Conformance test report of an

AIS system

Equipment under test: **McMurdo**

Test Report No.: 734.2/0066/2003/S3220

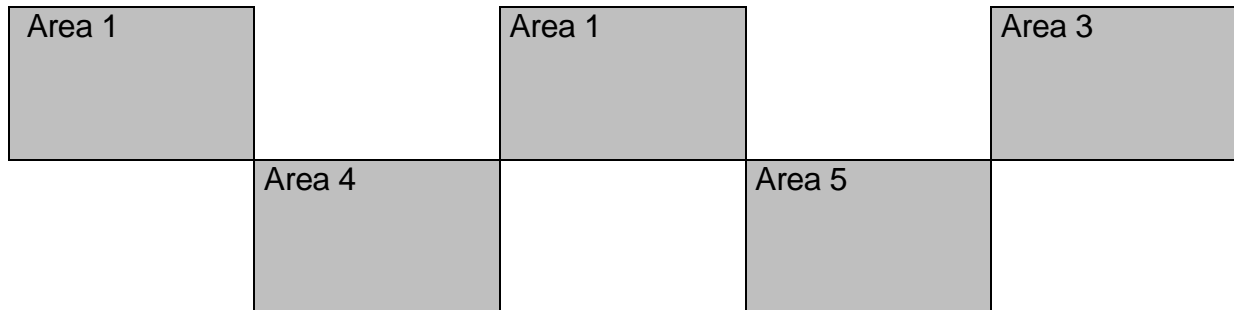
29.10.04	A change of the SW corner of Area 1 (in the picture below) is not accepted (from 51°00 51°05). There is a TXT output from transponder that there are too many corners within a range of 8 Nm <u>Retest 10.11.04 Ba:</u> Change of area is accepted now	Ok

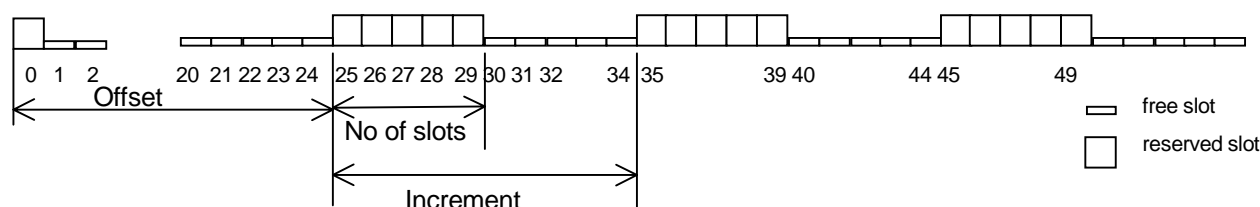
Note) According to ITU-R M1371, §4.4.1 and clarification 2.56 a slot reserved by a base station on the other channel has got the lowest possible priority, that means it can be used for candidate slots, but only if no other slot with higher priority is available.

In the actual test scenario there are normally at minimum 5 free slots (free on both channels – highest priority) available. Therefore there is no reason to use one of the low priority slots for candidates.

Note) accepted areas

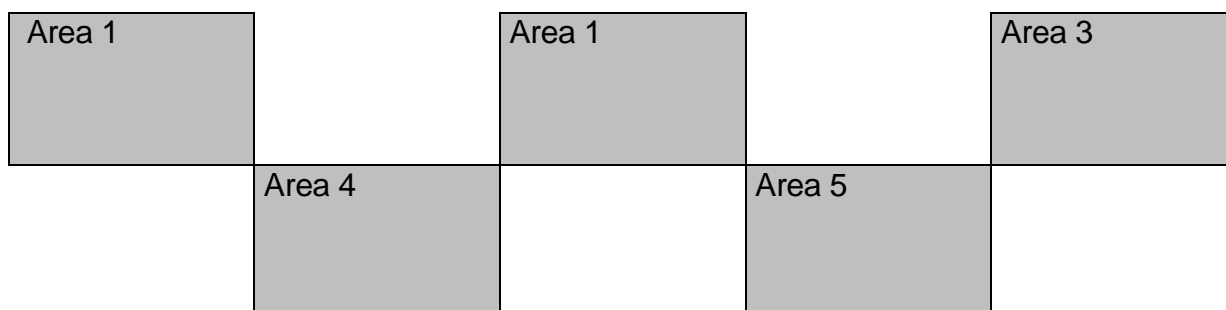
01.10.04 Ba	Area acceptance	<p>Areas No 4 and 5 as shown in "Note) accepted areas" are not accepted</p> <p><u>Retest 29.10.04 Ba</u></p> <p>Areas are accepted now</p>	Ok
